Re: Variance Request  
Town Creek Crossing Section 1  
City of Montgomery

V.S./V.B. VARIANCE EXHIBIT

RE: Variance request for Town Creek Crossing regarding Vegetative Setbacks and Barriers

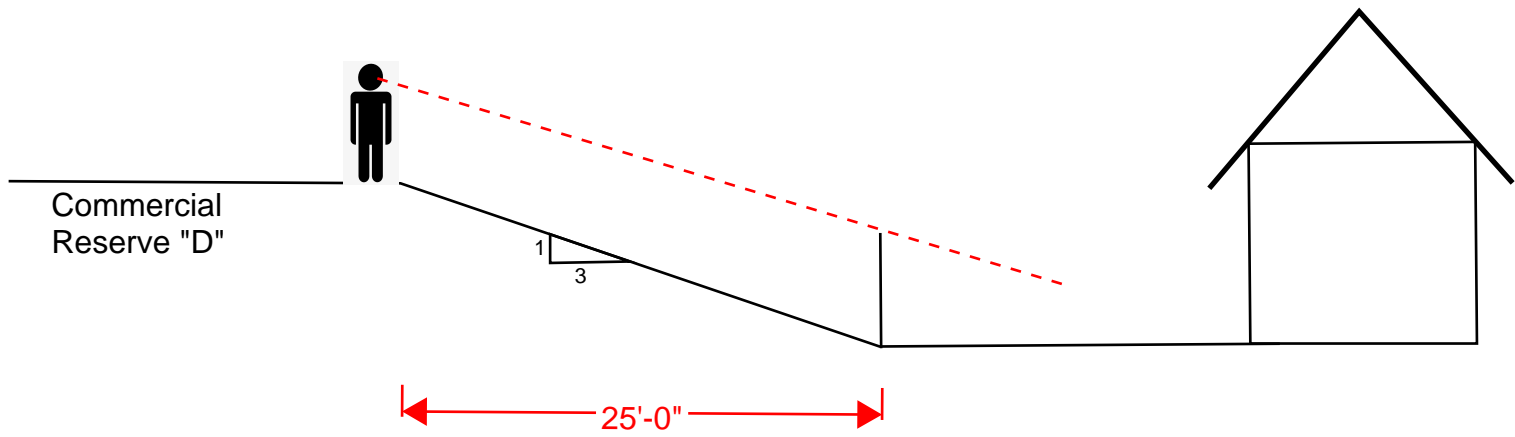
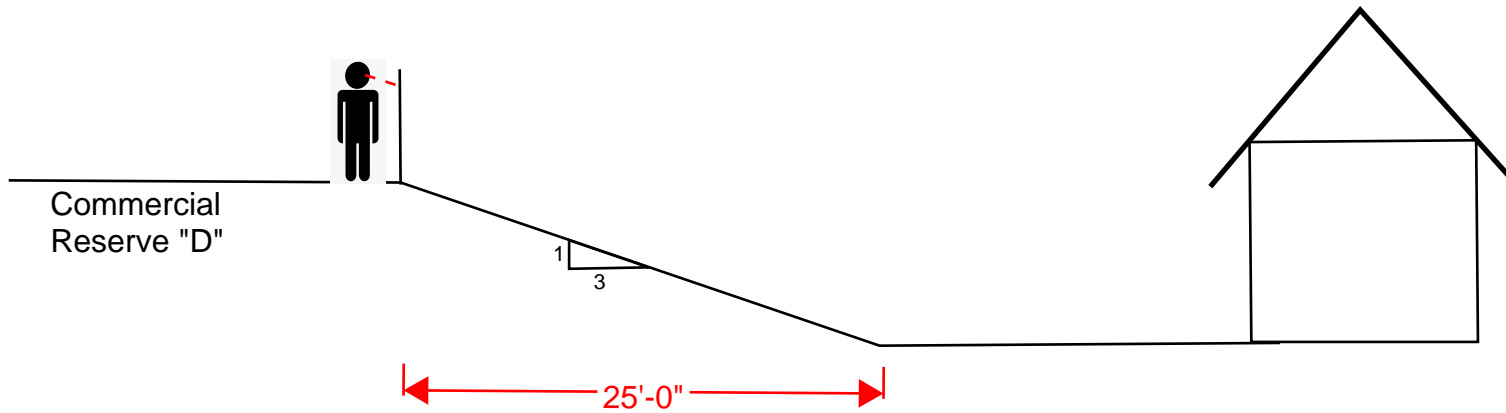
According to Section 78-162 of the 2002 City of Montgomery Code of Ordinances, a vegetative setback of 25' in width is required to be maintained at all times where commercial, multifamily, industrial, church, public building or school properties abut any single-family residential property. The ordinance is not specific to require the setback be located on the commercial lot, it simply states there a 25' setback is required; however, the 25' setback is typically situated on the commercial or multifamily property. We request that the 25' setback be situated on the residential lot in lieu of the commercial reserve.

There will still be a 25' buffer between Commercial Reserve D and the residential lots behind it, the setback will just be fixed on the residential lot. A fence will be placed on the common boundary line (approximately 7' higher in grade than the finished floor of the homes) and there will be a 3:1 side slope for transitional grading within the 25' vegetative setback on the residential lots. The residential lot depths were also increased in size by 25' to accommodate this setback.

Enclosed you will find the request for variance as submitted by the engineer for the development. We offer no objections to the Developer’s request on the basis of the significant elevation difference between the commercial reserve and adjacent single family residential properties, and the lot size adjustment that is proposed to account for adjusting the location of the vegetative buffer.
